NOTICE OF INTENT TO ADOPT A NEGATIVE DECLARATION NOTICE OF PUBLIC REVIEW AND COMMENT PERIOD

PROJECT: 1240 Chanticleer Ave. 2-lot Minor Land Division

Application #: 151145

Re: Plan check comment response from Department of Public Works Drainage 1240
Chanticleer Av., Santa Cruz, CA APN: 029-191-13

GRADING AND DRAINAGE PLAN
SCALE: 1"=10'

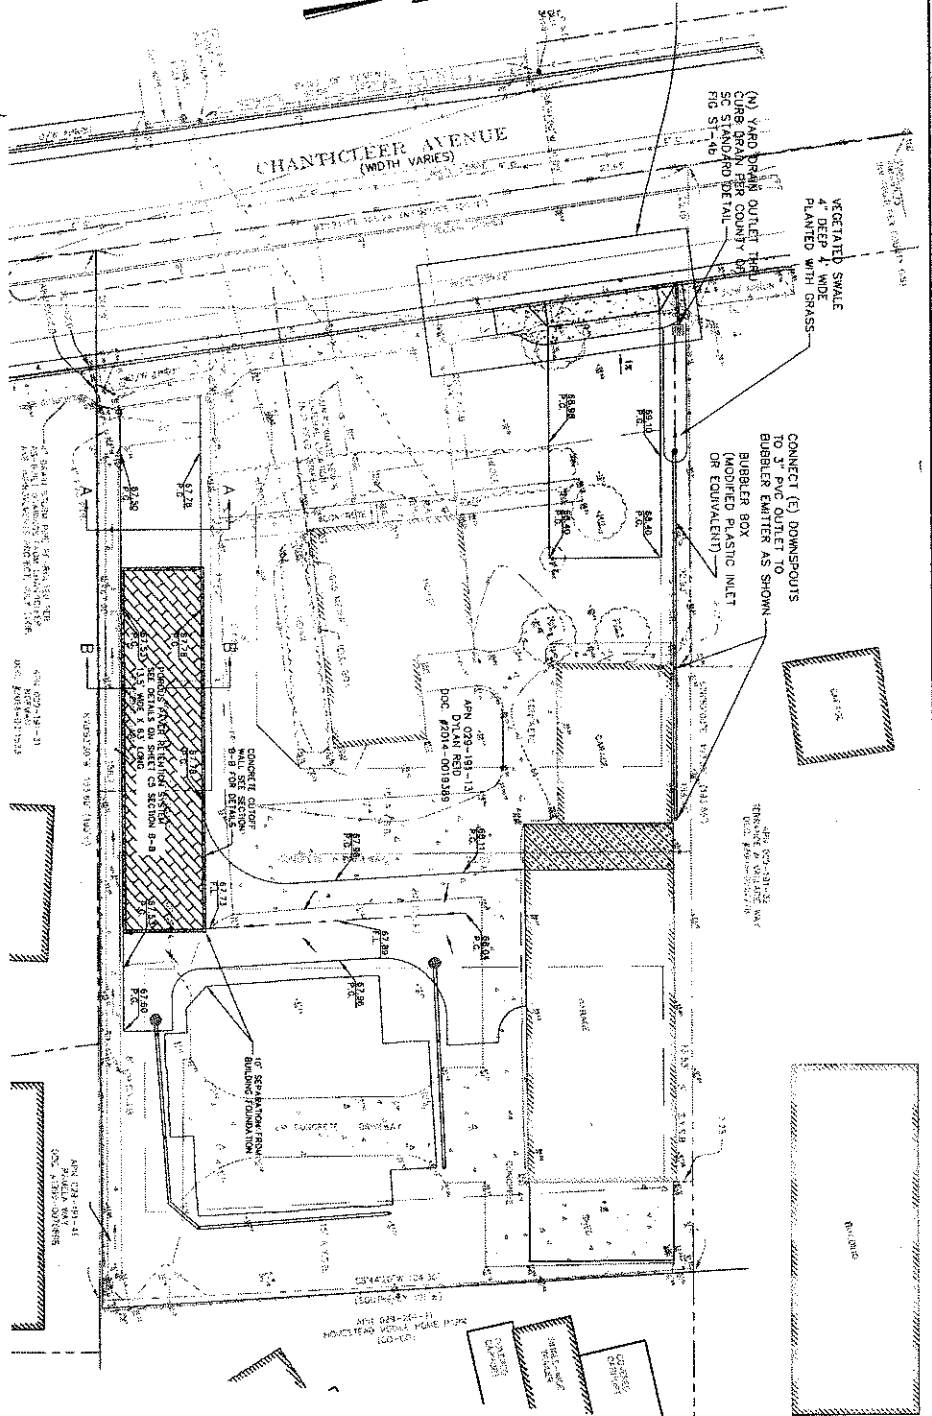
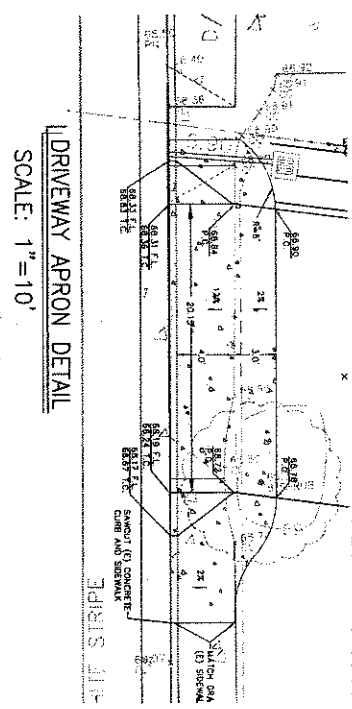
2) Given the flat site, in order to evaluate the feasibility of the proposed drainage design and watershed boundaries, please update sheet P2 to clearly show:

If possible, provide a box and undersidewalk drain to provide a safe overflow path from this retention system to Chanticleer Avenue. Alternatively, the proposed swale can be built as a retention trench at least 3 feet deep to reach the more pervious soil layer.

Response: C2 Updated as requested. Both C1 and C2 now showing extents for new impervious with hatching.

Response: Bubbler boxes have been removed from the project. The proposed undersidewalk drain has inverts shown. The flowline elevation of the existing concrete ditch and outlet PVC pipe are shown in topo points and have been clarified on this drawing. Proposed swale flowline elevations have been shown.

Response: All requested items are shown. The upper parking area is now a 3' deep section of porous pavers over drain rock. This value has been omitted from the drain calculations as impervious since it is now self-mitigating.
